FAIRFIELD  
RESIDENTIAL

content SECTION 3 / scale 1"=60'-0" / project 5638.00 / date 06.09.2016

VIEW ON TOTEM LAKE WAY LOOKING NE

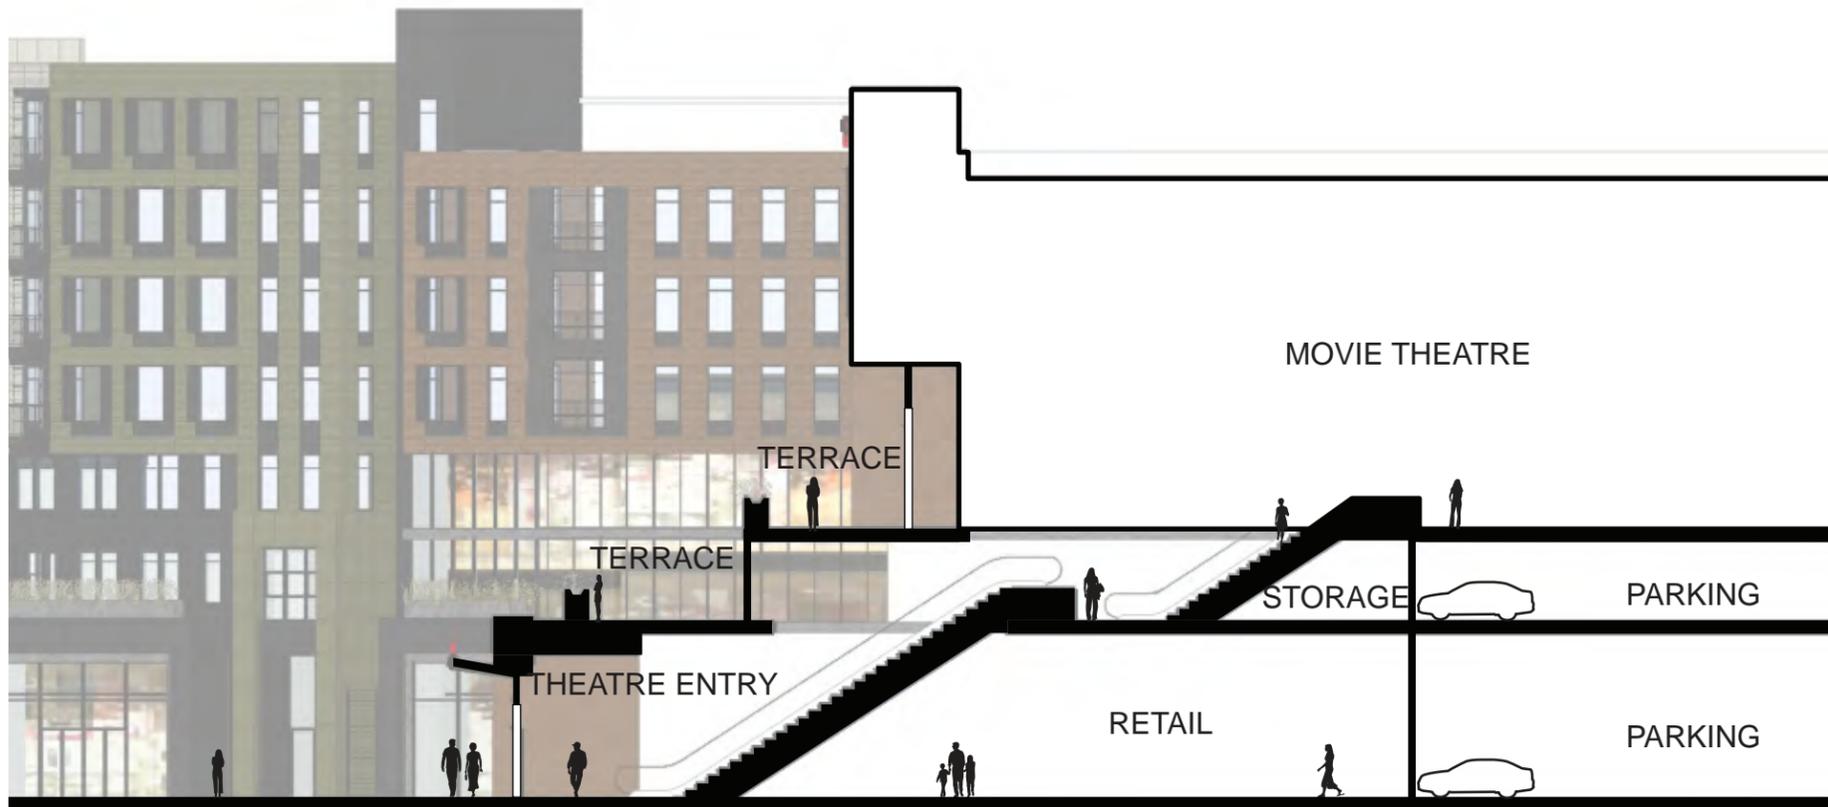
Provide more detail regarding the design of the facades that are visible behind the existing Chase Bank as well as the main retail parking entrance off 120th adjacent to the bank

Immediately behind the bank on the west façade the project proposes three levels of above grade parking finished in a dark metal panel with louvers at the ground floor. Above the parking four levels of residential use in a hardie board finish are also articulated with windows matching the parking fenestrations and the hardie board material is extended to emphasize the corner facing Totem Lake Way. On the south façade at ground level a prominent retail corner is expressed with above grade residential further articulating the corner element with unit balconies. The parking on this façade is also finished with a combination of hardie board and metal louvers for air intake. The main retail parking entry on 120th is setback 43 feet and will be composed of a high grade metal tilt up gate.

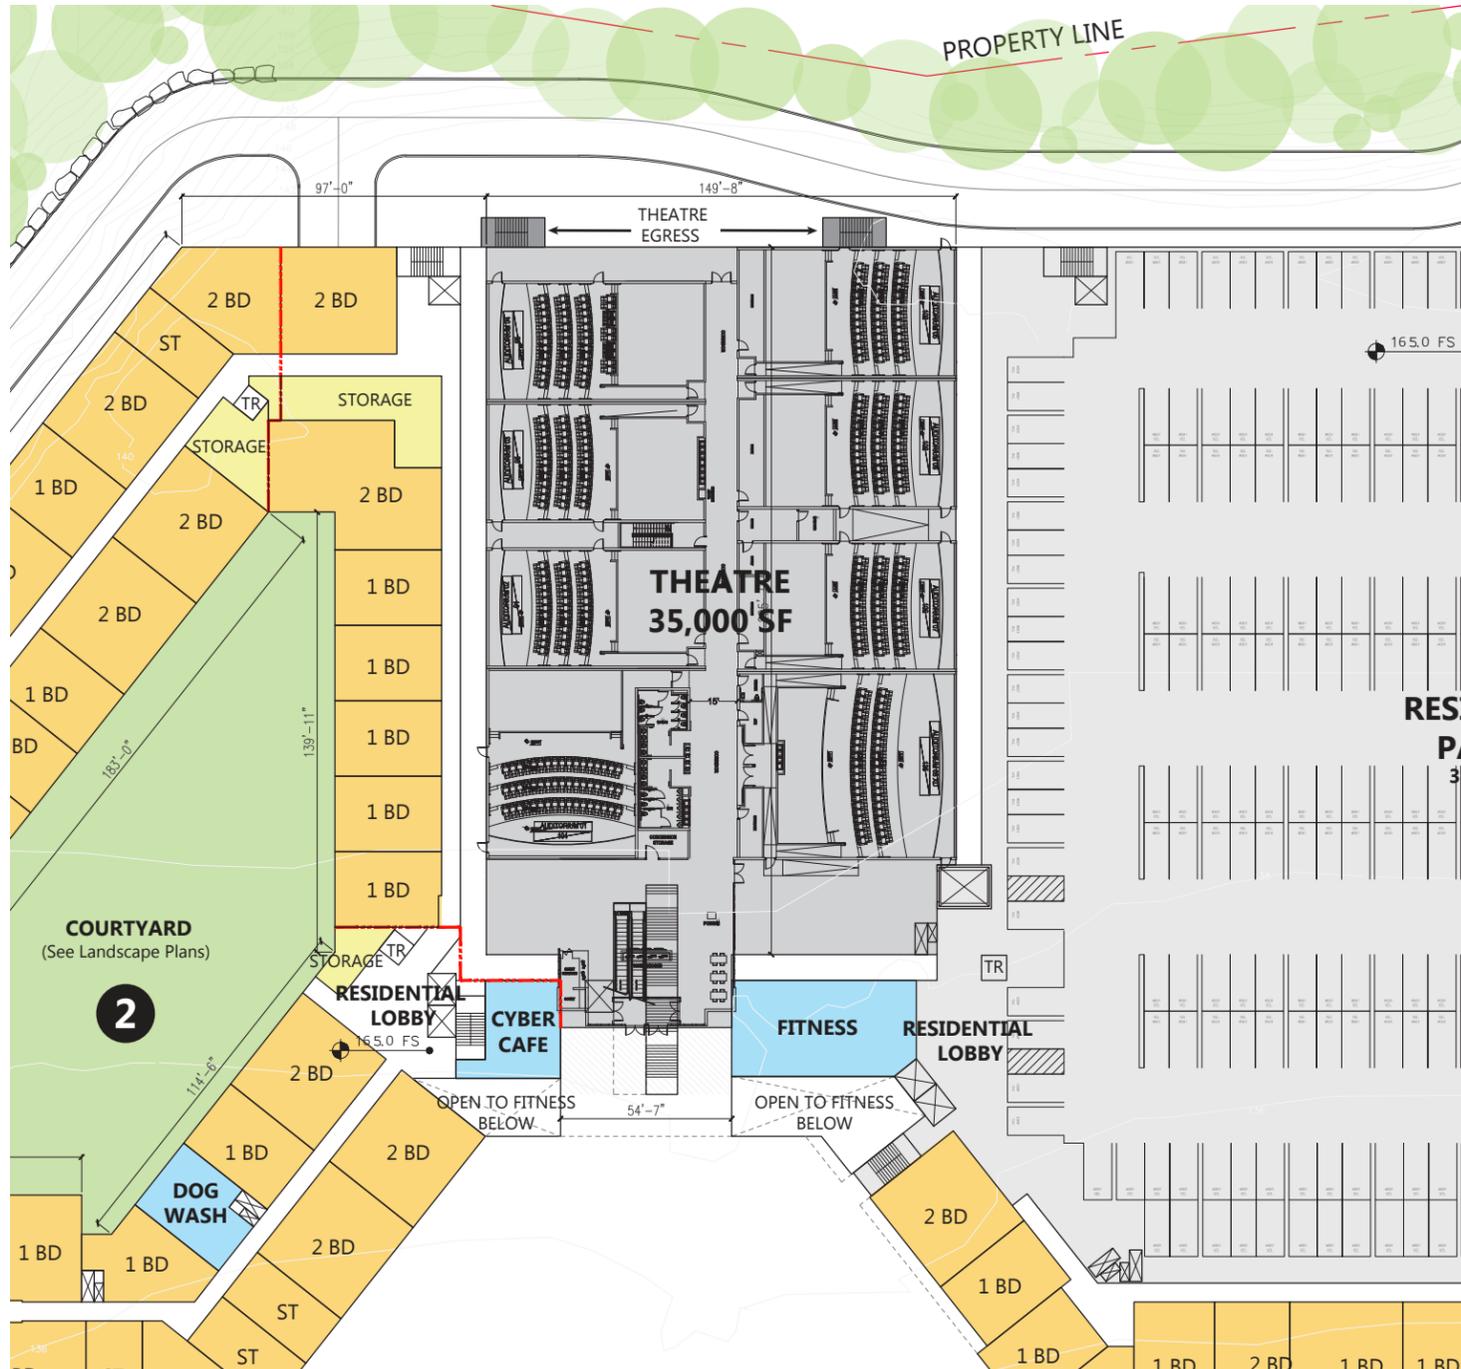
Since the movie theatre is not seven stories tall, can the top become anything other than a roof? What is the relationship of the theatre to the plaza? How does it look and how does it work with the rest of the project? Is it well integrated with the residential component?

The relationship of the theatre to the plaza as well as the residential component has been further studied. The result is an eighty five foot deep and twenty foot tall retail space has been reprogrammed at the ground level. The proposed retail space for a potential restaurant includes outdoor seating. Retail parking for 412 cars also occurs at this level concealed behind the retail space. A grand staircase and escalator will take visitors to the third level where the theatre is now proposed with an outdoor space overlooking the plaza. At Level 2 residential parking is proposed concealed by residential amenities also with outdoor spaces facing the plaza. The top of the theatre now better aligns with the residential component.
